Notice of Allowability

10/648,397

Annotated Marked-up drawings

FIG.25

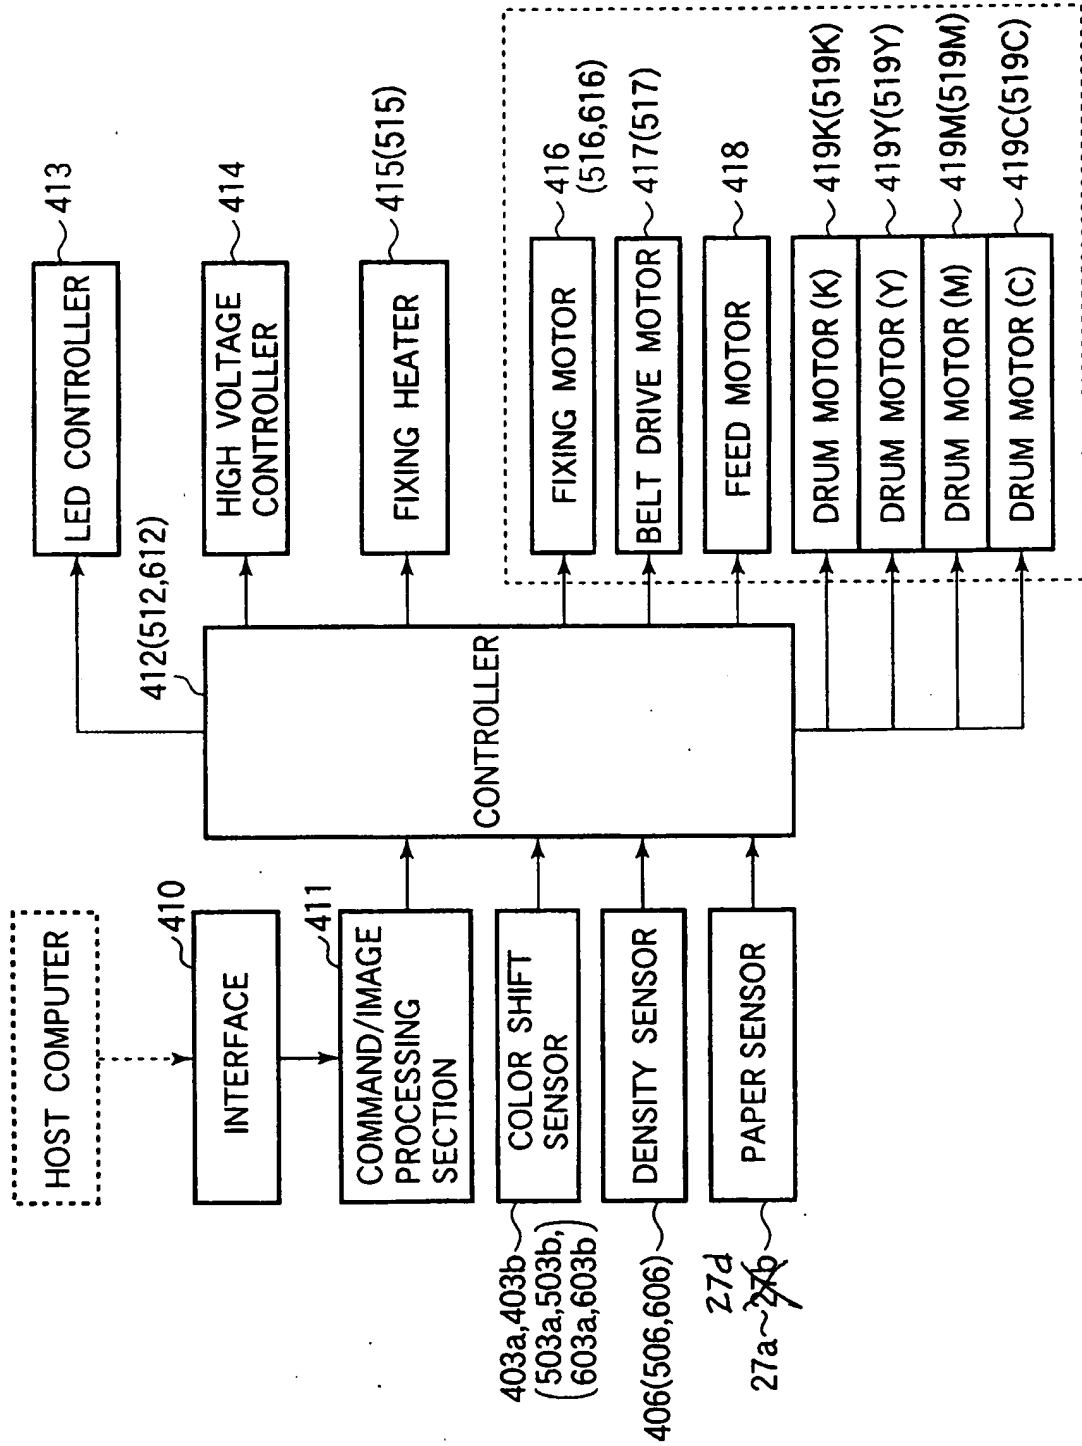
Correction
around
mm
2/22/85

FIG. 26

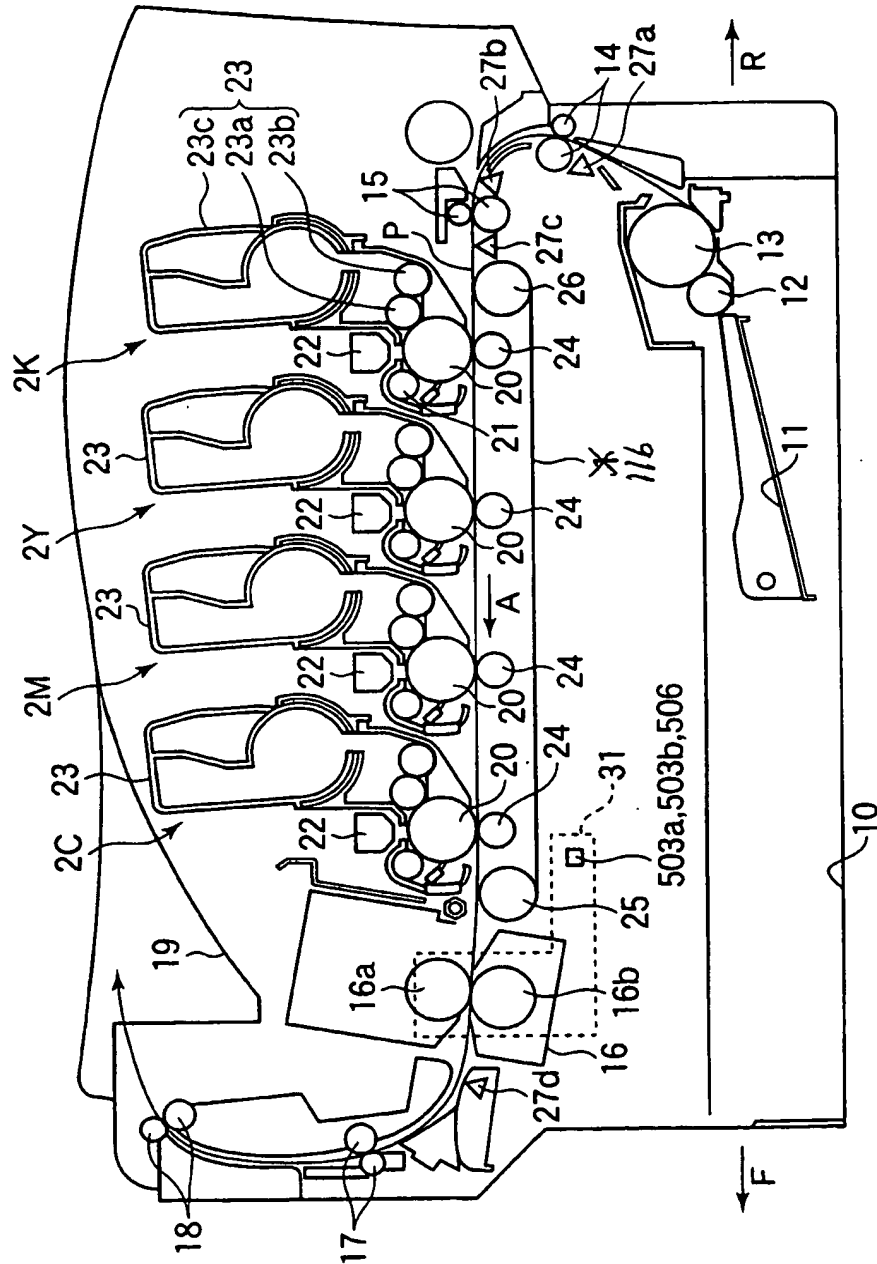
Correction
applied
MGR
7/22/05

FIG.28

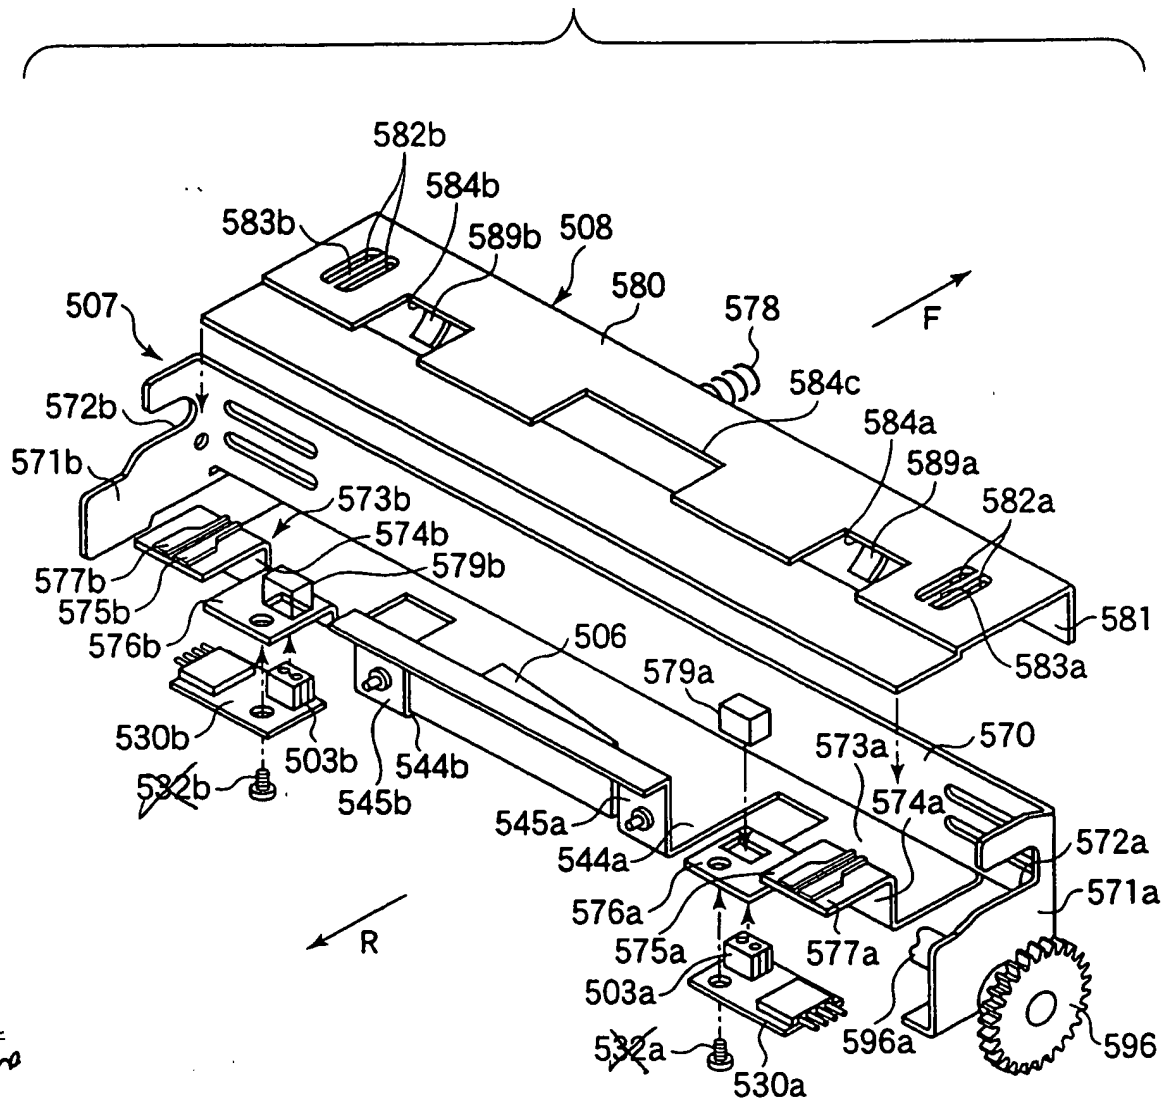
Connections
downward
again
7/22/05

FIG.30A

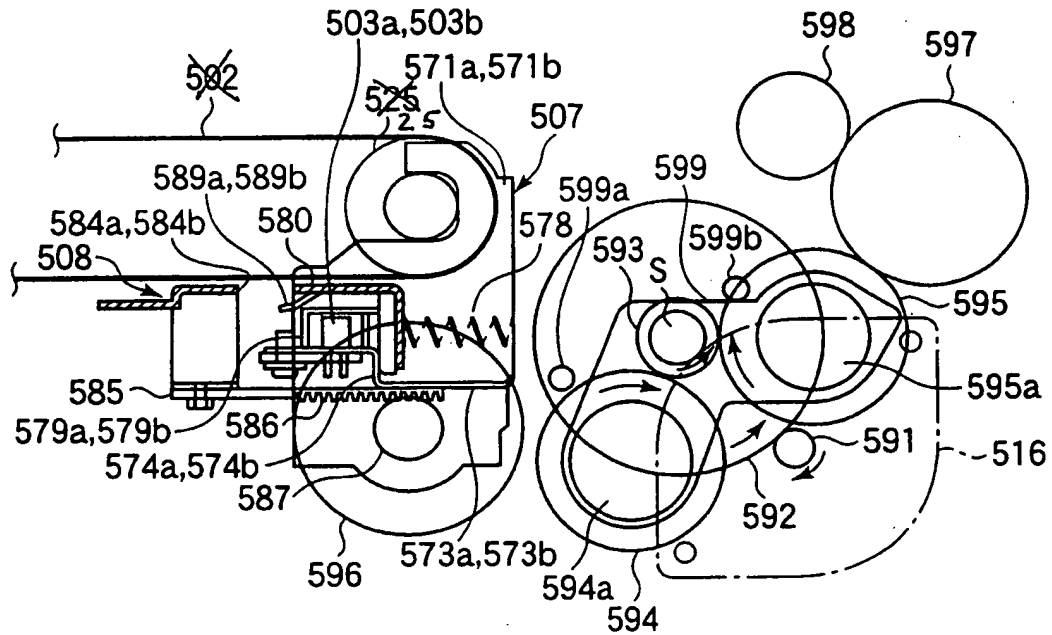
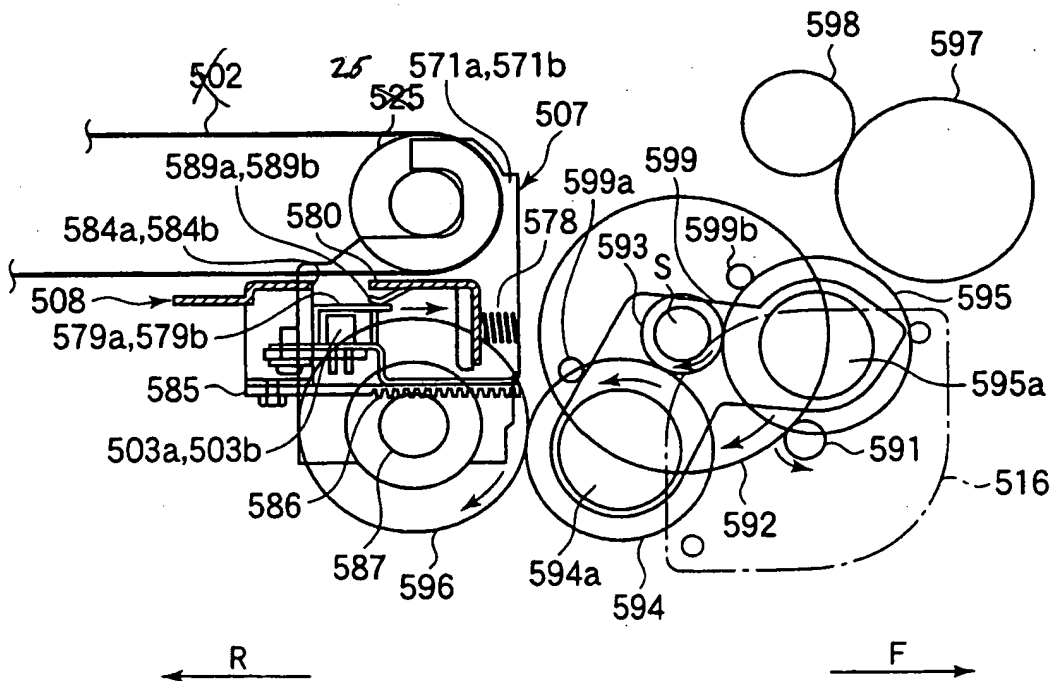
Correction
around
MPL
7/22/05
